KILDARE COUNTY COUNCIL

PLANNING DEPARTMENT

Type of Development:	<p>Refurbishment of an existing 1 bed semi-detached single storey house to wheelchair accessible 2 bed dwelling including works to the party wall. Works also include construction of a new 3 bed single storey detached house on the remainder of the site.</p> <p>The proposed development involves construction of a single shared entrance including new boundary hedges and fences, and carparking areas, site development works including landscaping, drainage, ancillary site services and reinstatement of public footpath along the R448</p>
Site address	Skenagun, Castledermot, Athy, Co. Kildare
Development proposed by:	Housing Department
Display period:	Advertised in the Leinster Leader on 2 nd April 2024

<p>Part 8 site notices were fixed at the site on 2nd April 2024</p> <p>Public display period from 3rd April 2024 to 2nd May 2024</p> <p>Submissions/observations due by 4pm on 16th May 2024</p>
Submissions/observations	Kildare County Council received 2 public submissions, 7 reports were received from internal departments within KCC and 3 reports/comments from Prescribed Bodies
Part 8 Reference Number	P8 2024-09

Fig 3 – Proposed Site Layout Plan

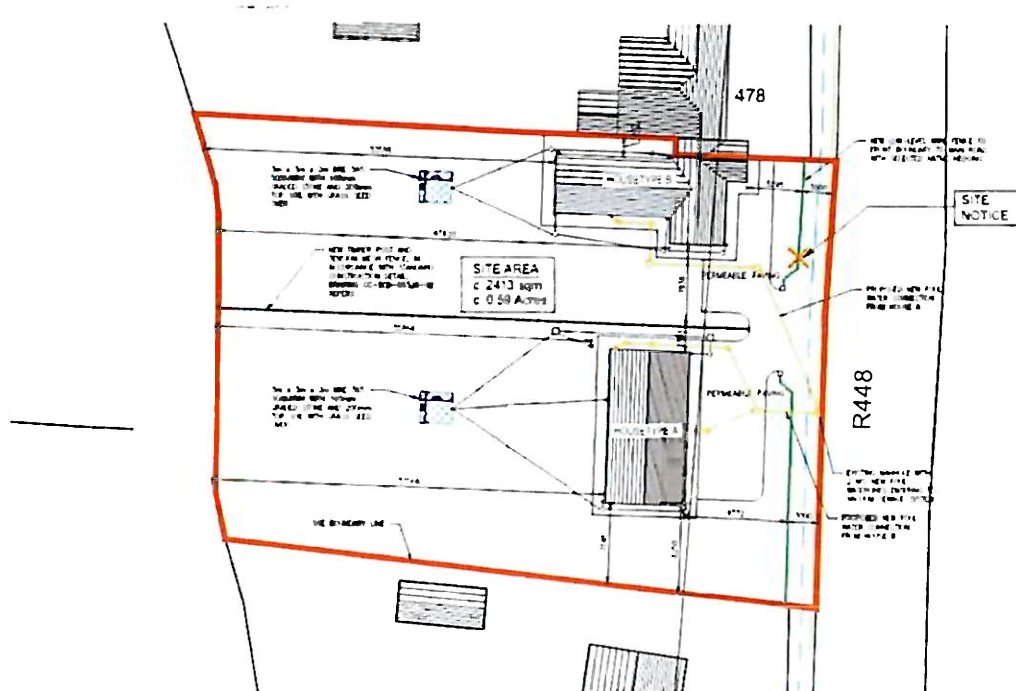
The proposed development includes the construction of a single storey detached dwelling with 3 no. bedrooms (Unit A). The proposed floor area of Unit A is 101.2 sqm.

It is also proposed to renovate an existing 1-bedroom single storey semi-detached dwelling (Unit B) to provide a 2-bedroom dwelling with wheelchair access. The proposed floor area of Unit B is 85.4 sqm. Sufficient storage space has been provided.

The existing building line is being maintained. External finishes include a mix of natural stone and render which is considered acceptable. The height of the proposed units (single storey) is considered acceptable.
